**UNITED STATES
NUCLEAR REGULATORY COMMISSION**
REGION IV
1600 E. LAMAR BLVD.
ARLINGTON, TX 76011-4511

**SUBJECT: ARKANSAS NUCLEAR ONE – NRC INSPECTION REPORT 05000368/2016011
AND PRELIMINARY WHITE FINDING**

ARKANSAS NUCLEAR ONE – NRC INSPECTION REPORT 05000368/2016011 AND
PRELIMINARY WHITE FINDING – JANUARY 19, 2017

IR 05000368/2016011; 09/16/2016 – 12/21/2016; Arkansas Nuclear One, Unit 2; Inspection Report; Follow-up of Events and Notices of Enforcement Discretion.

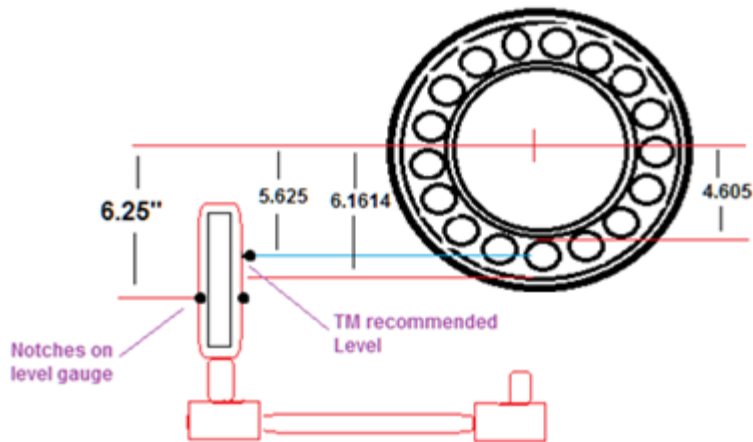
The inspectors reviewed the licensee's corrective actions after a licensee engineer discovered, during reassembly, that the oil level scribe mark on the repaired bearing was again below the vendor recommended level, but above the minimum level for lubricating the bearing (CR-ANO-2-2016-3722). The inspectors reviewed the sleeving modification of the generator shaft and corrective actions for damage that occurred when the new shaft sleeve contacted the repaired bearing housing cover while manually rotating the engine (CR-ANO-2-2016-3435).

AREA: B	ELEV: 368'-0"	ZONE: 2200-MM		
ARKANSAS NUCLEAR ONE UNIT 2 RUSSELLVILLE, ARKANSAS			SCALE : NONE	
			DRAWN : C. DUNAWAY	
FIRE ZONE DETAIL TURBINE BUILDING CONDENSER AREA		DESIGN : ENTERGY		
		CAD NO : 00020186.f2r		
		DETAIL NO.	SHEET	REV
		FZ-2037	1	2

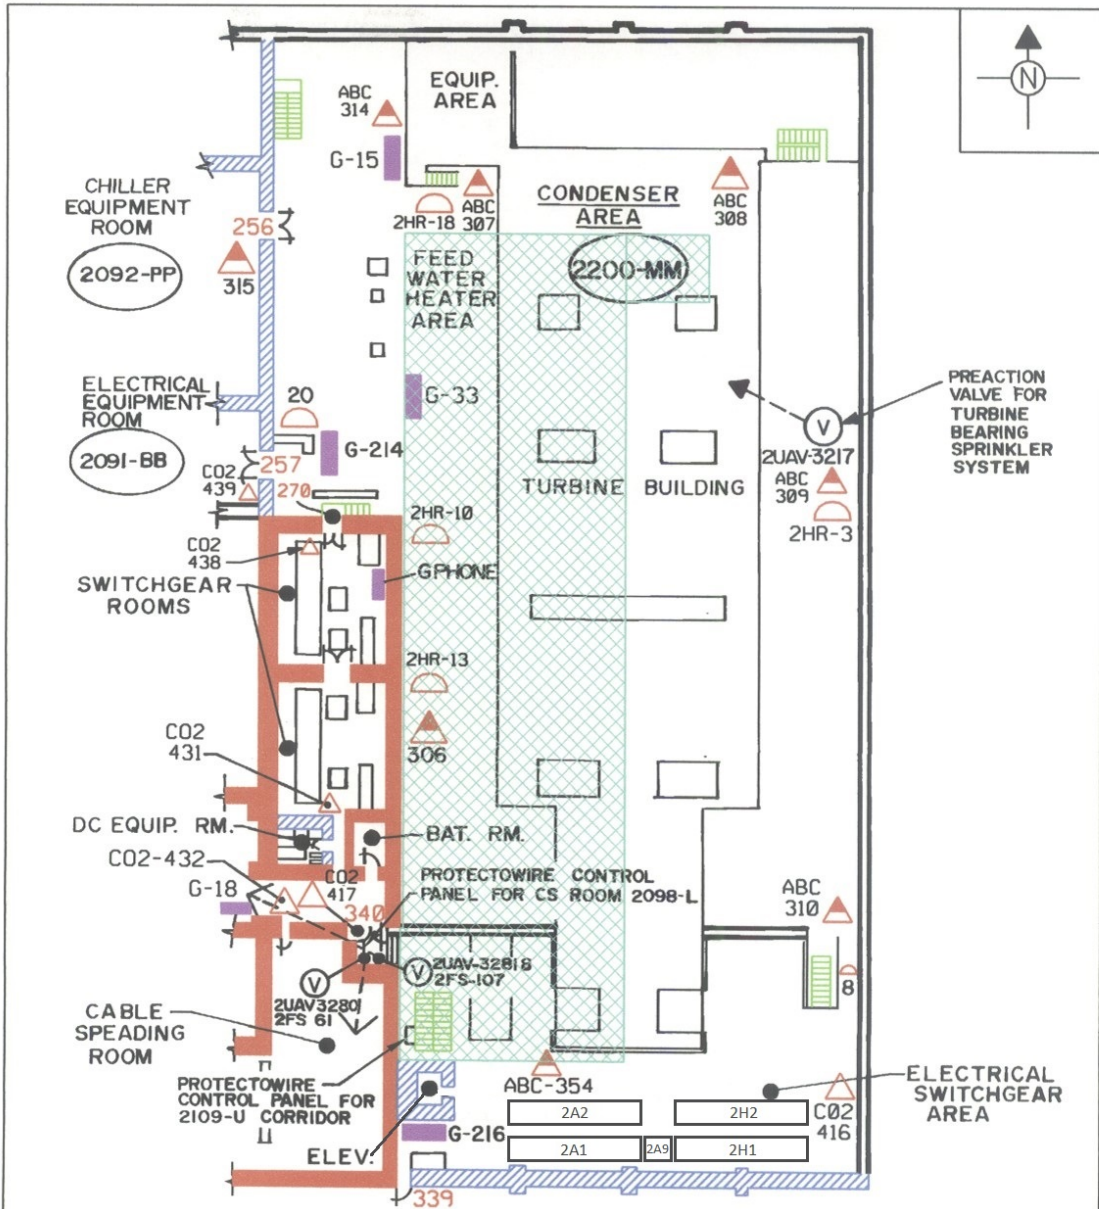
As shown in the following figure (taken from the ANO Unit 2 pre-fire plans and enhanced for emphasis), the simplified modelling assumed a fire in switchgear 2A1 would always affect switchgear 2A2 because of their close proximity to each other (6 feet apart). Likewise a fire in switchgear 2A2 would always affect switchgear 2A1. The same spatial relationship and fire

Walkway between 2A1/2A2 and 2H1/2H2 is 6 feet wide.
 Space between 2A9 and 2A1/2H1 is 6 inches wide.

spread assumptions applied to switchgears 2H1 and 2H2. Switchgear 2A9 is situated between switchgears 2A1 and 2H1 and is 6 inches from each switchgear.
